ADDENDUM No. 2

PROJECT NAME: Alamo Plaza Visitor Information Center Office Renovation ID No.:43-00001

DATE: January 13, 2015

97" UPRIGHTS, 4-POST EXACT
SHELVING ON MOBILE AISLE 1000 SYSTEM
ELEVATION VIEW

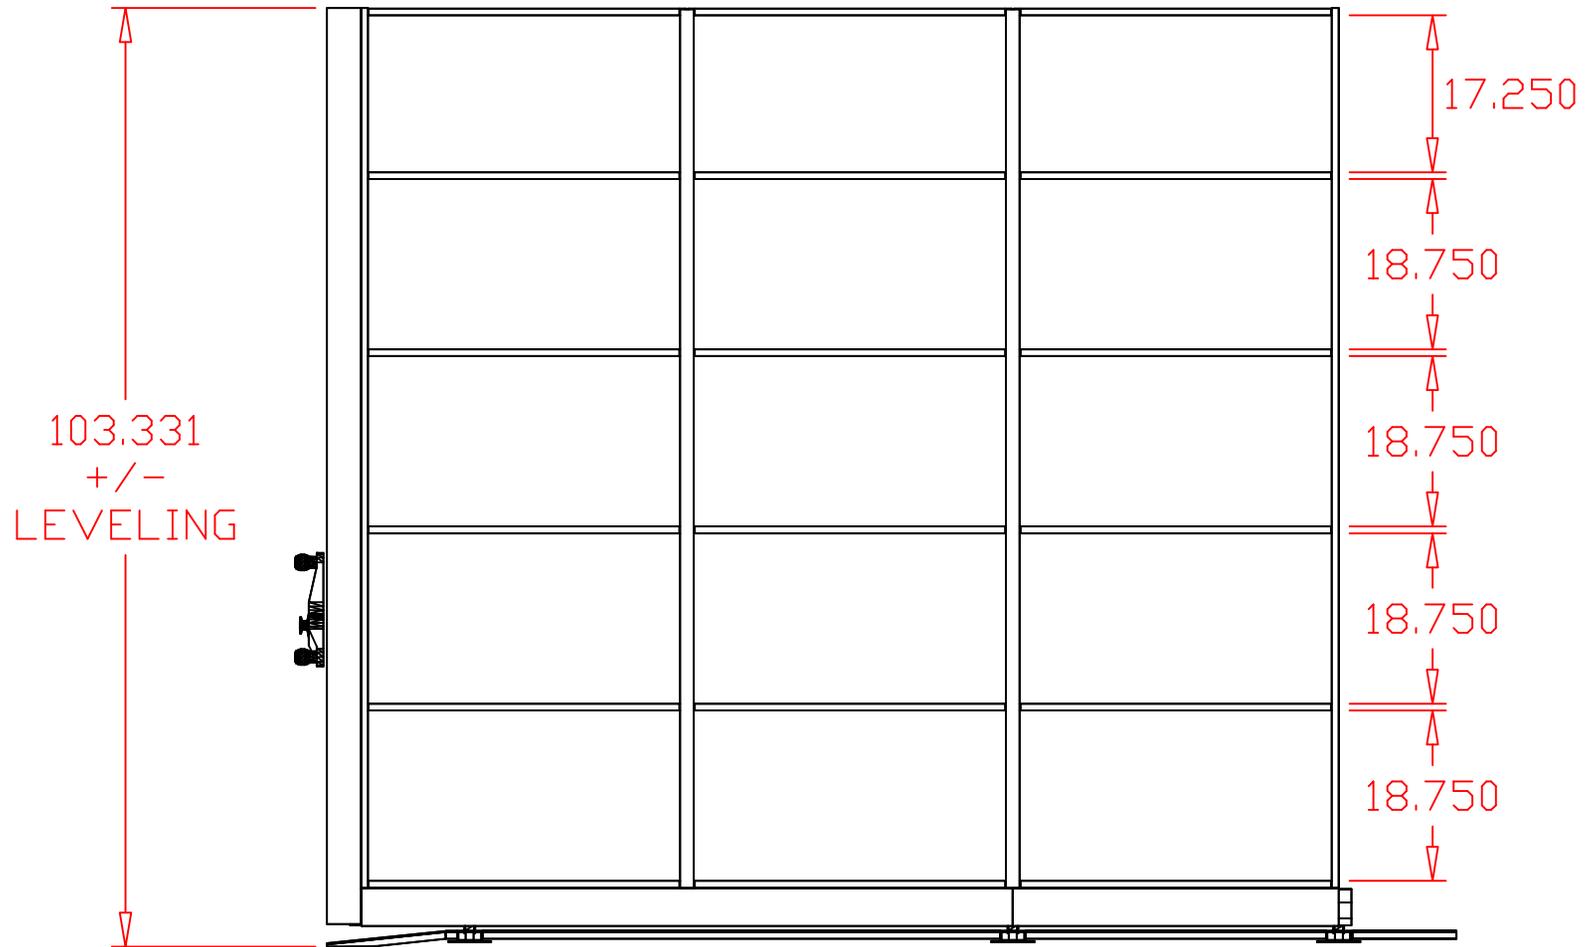
6. **Question: Where is the "New Mobile Shelving System" Specified? Not included in the specs. The Demo plan indicates for us to remove and store, are the existing to be reinstalled?**

Response: Refer to attached **EXHIBIT 'D'** for mobile shelving requirements (included in specs, but not referenced in Table of Contents. Refer to Question 8 below regarding existing shelving.
